Re: Turkey Point Units 3 & 4
Docket Nos. 50-250 & 50-251
Environmental Qualification of
Safety-Related Electrical Equipment

ENVIRONMENTAL QUALIFICATION OF
ELECTRICAL EQUIPMENT
IE BULLETIN 79-01B

RESPONSE TO
THE SAFETY EVALUATION REPORT
BY THE OFFICE OF NUCLEAR REACTOR REGULATION
EQUIPMENT QUALIFICATION BRANCH

FLORIDA POWER & LIGHT COMPANY
TURKEY POINT UNITS 3 & 4
DOCKET NO. 50-250/50-251

FIG. 68 STEAM TEST 3, TEMPERATURE RESULTS.

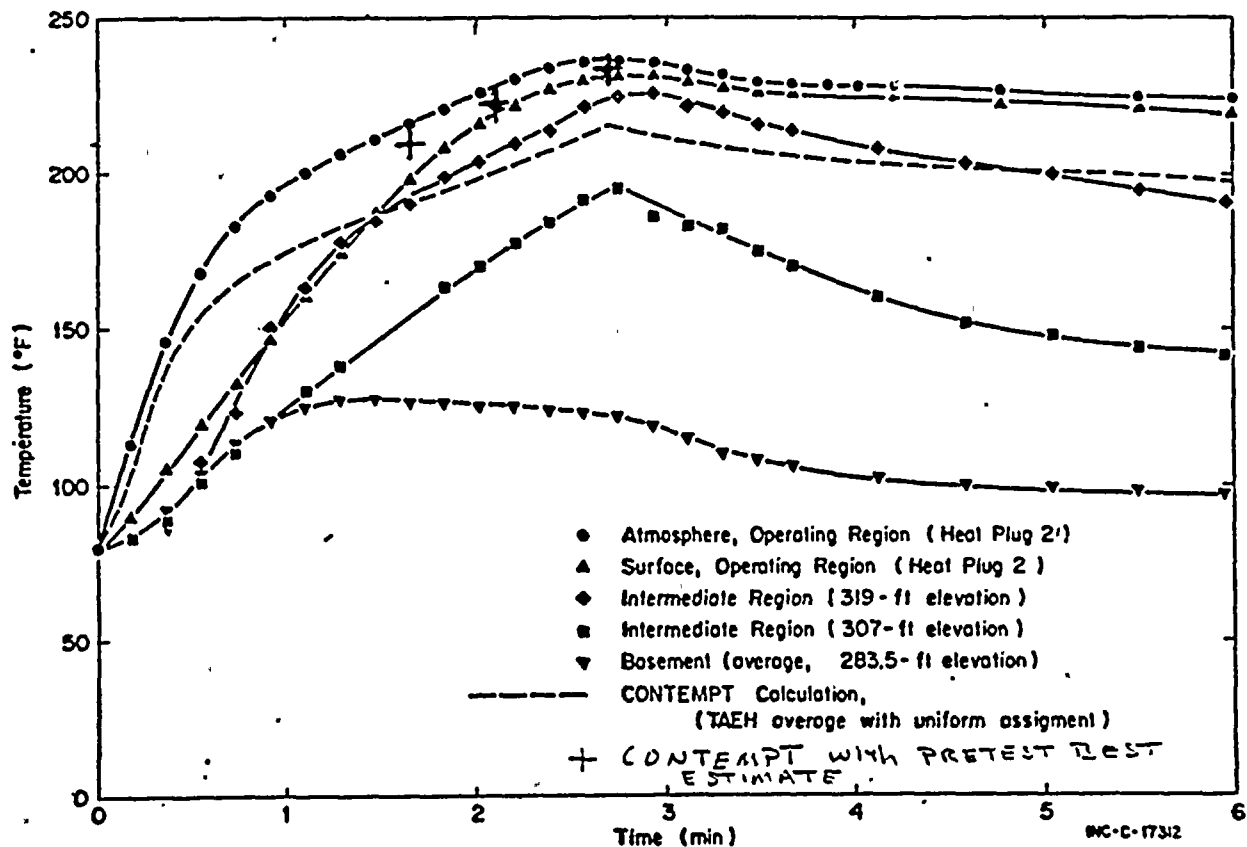
The licensee's specified temperature (service condition) of 276°F does not satisfy the above requirement. A saturation temperature corresponding to the pressure profile (298°F peak temperature at 50 psig) should be used instead. The licensee should update his equipment summary tables to reflect this change.) If there is any equipment that does not meet the staff position, the licensee must provide either justification that the equipment will perform its intended function under the specified conditions or propose corrective action.

The NRC position would impose a 22°F margin (298 vs. 276°F) to account for CVTR indicated stratification which test data clearly shows is short-lived. The stratification manifests itself prior to the containment spray system becoming effective. Once the containment spray is initiated, the temperature converges very rapidly such that after 15 minutes the temperature difference is approximately 10°F (see Figure 55 of Reference 1). Thus, the stratification phenomenon is short-lived and should only be considered relevant to the peak of the temperature transient.

CVTR report. Figure 63 of the CVTR report shows the pressures which would result from a CONTEMPT analysis using measured steam injection rates and design basis heat transfer correlations as used in the Turkey Point containment response analysis. Using Figure 63, a CONTEMPT temperature analysis using design basis heat transfer correlations can be shown to be within 5°F of the maximum reported in the CVTR test. A comparison is shown as marked up on Figure 68 of the CVTR report (page 8).

In summary, the Turkey Point temperature response is an adequate basis for temperature qualification. The DBA analysis is already sufficiently conservative to account for any temperature stratification, as the mass and energy releases to the containment are maximized, and a lower bounding passive heat sink heat transfer correlation is utilized.

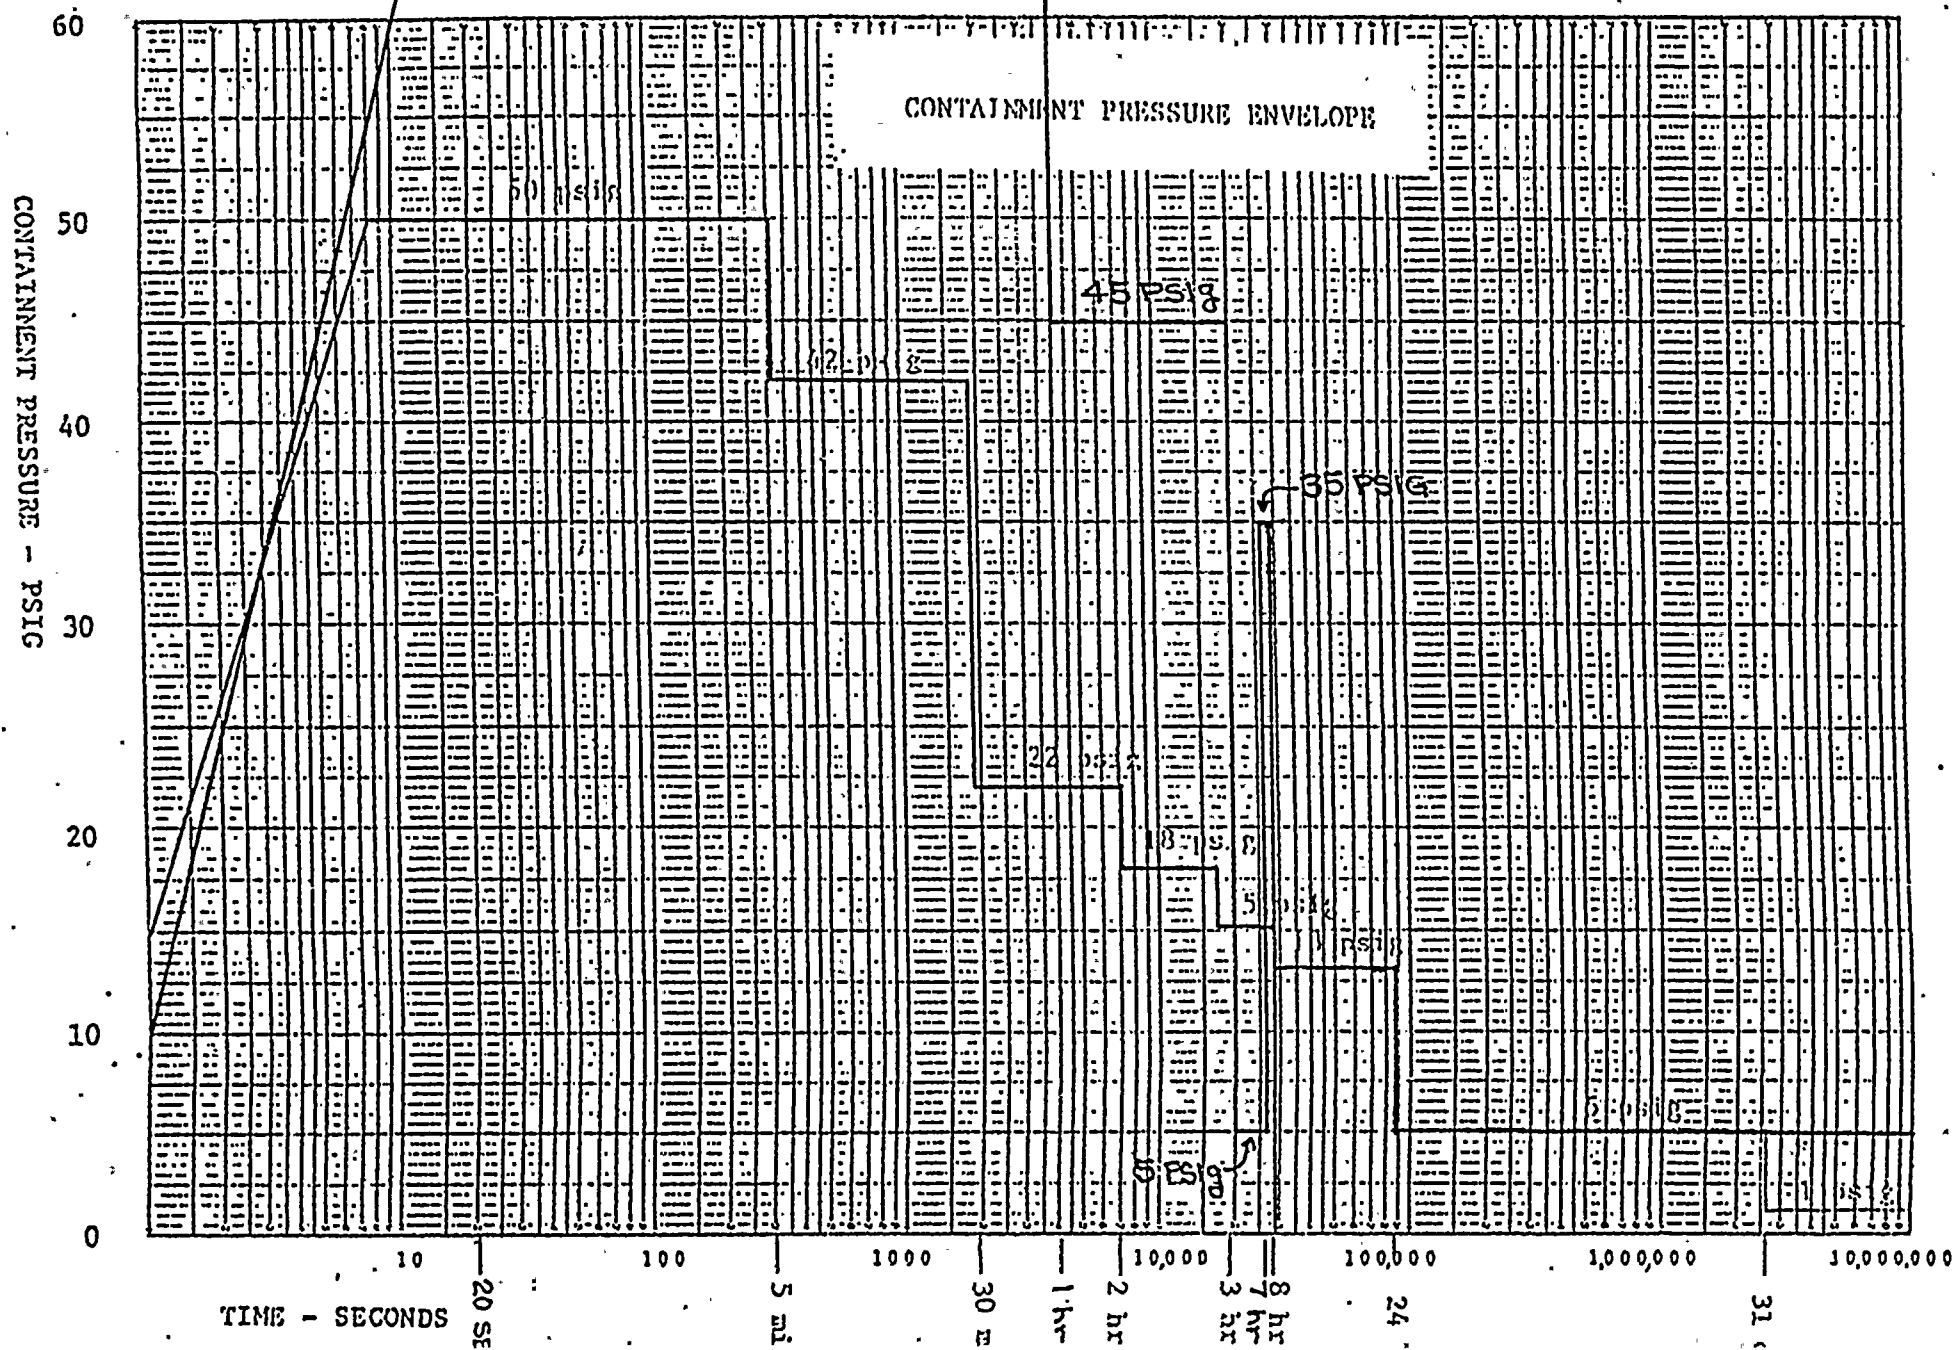
DEFICIENCY CODE IDENTIFIED IN S.E.R.:

P (Pressure) See the attached superimposed test profile over the post accident profile. The test profile envelops the accident profile during the test duration of 7 hours with adequate margin. Having withstood a pressure much higher than the required pressure for a 7 hour period, it is reasonable to conclude that the transmitters will withstand a much lower pressure for an extended period of time.

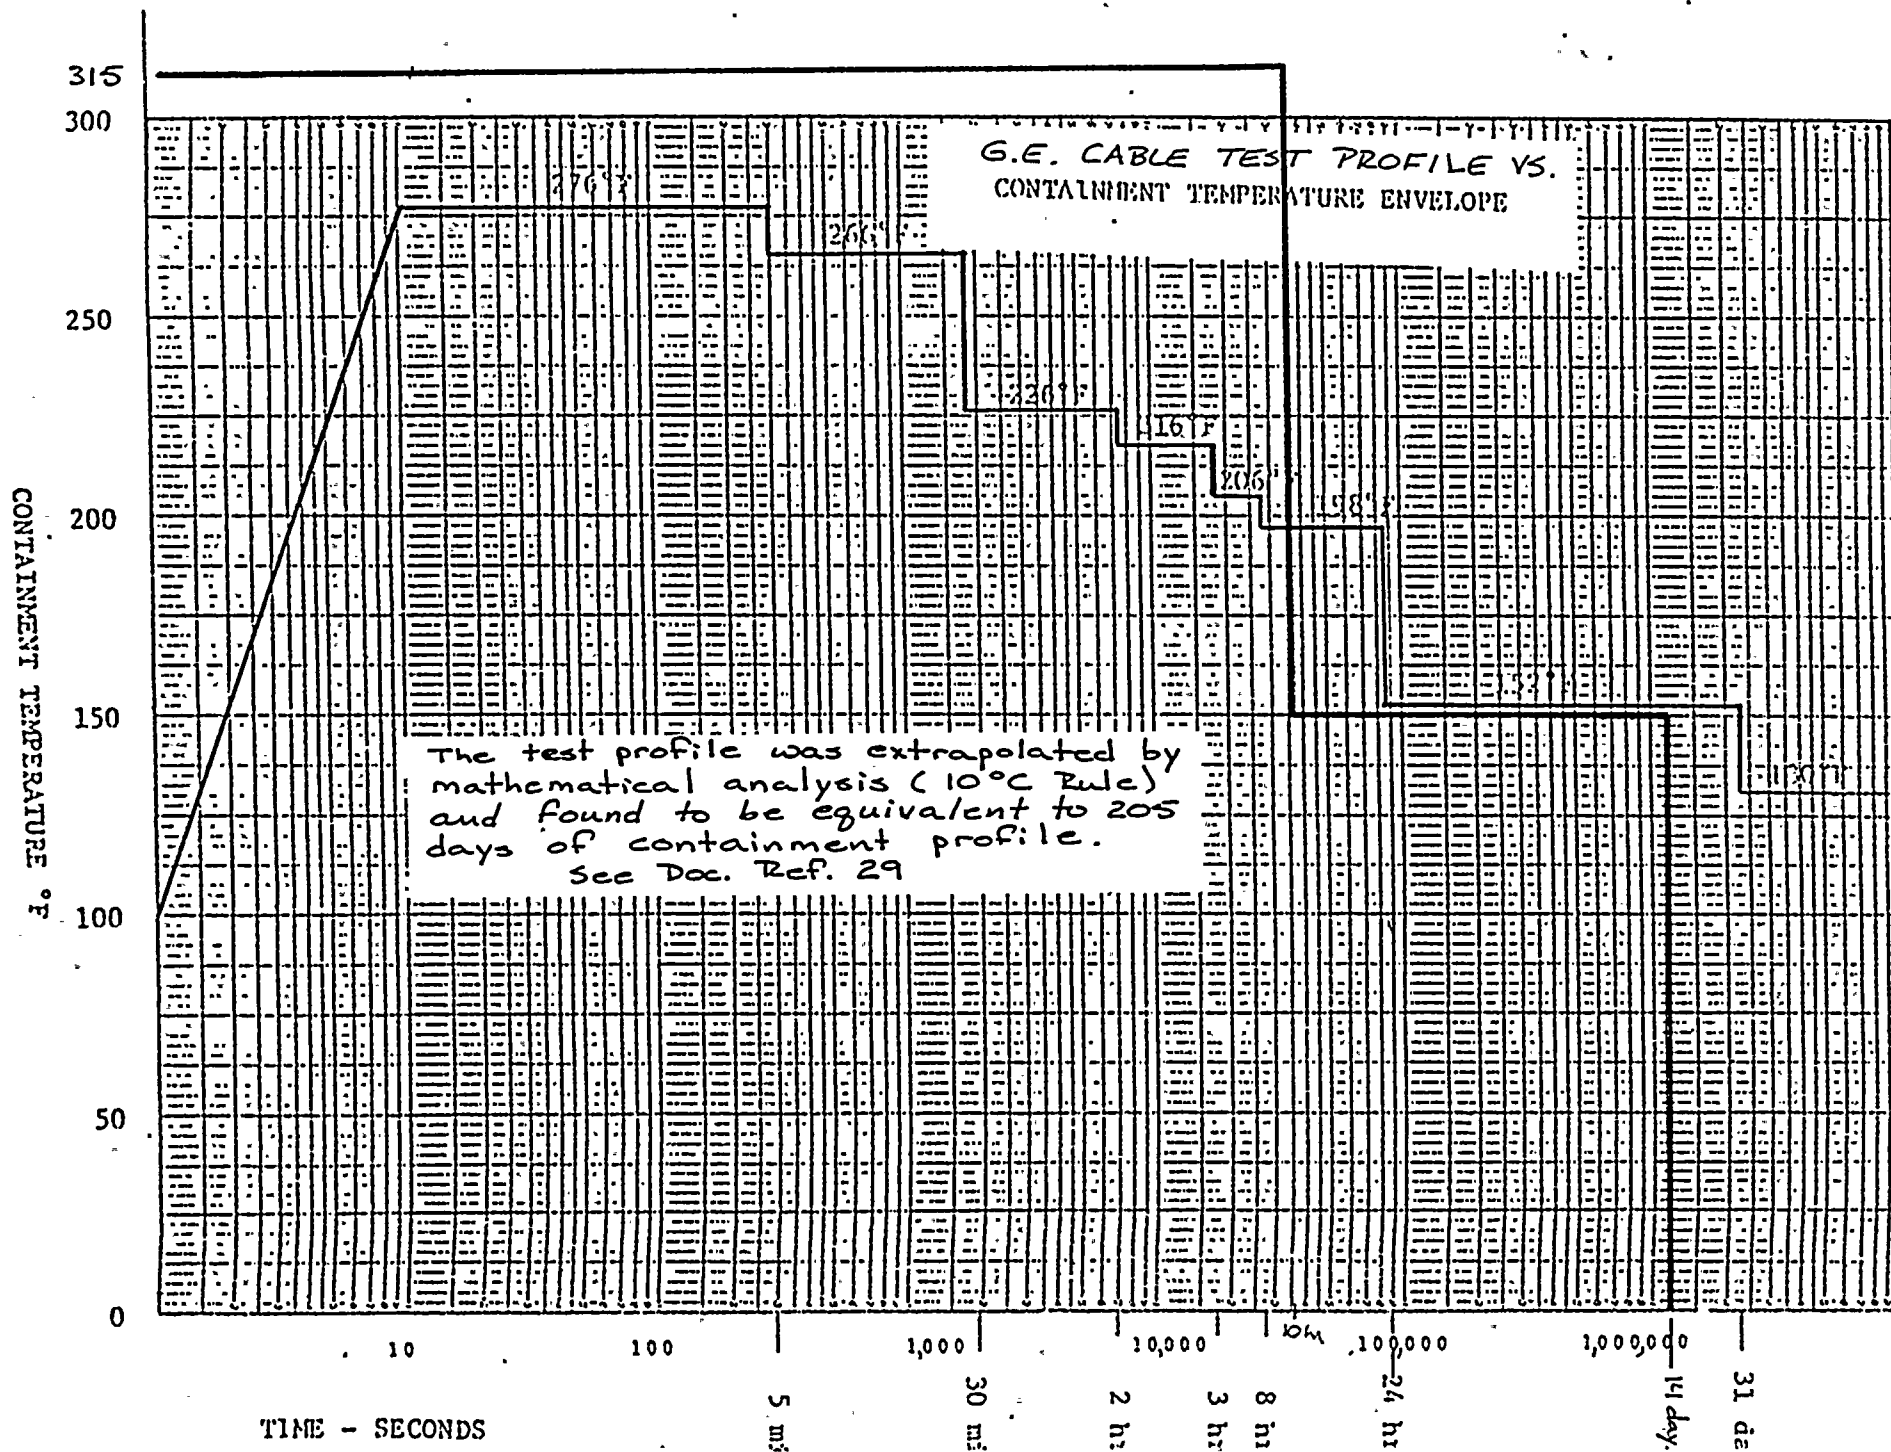
DEFICIENCY CODE IDENTIFIED IN S.E.R.:

T (Temperature) Although the test profile was of shorter duration than required, it was much more rigorous in the first ten hours than the containment profile. A mathematical analysis was performed to extrapolate the first 10 hours of the test by the 10°C rule. This method is generally acceptable for cable insulations. The cable is qualified to the containment temperature profile for 205 days. (See attached sheet).
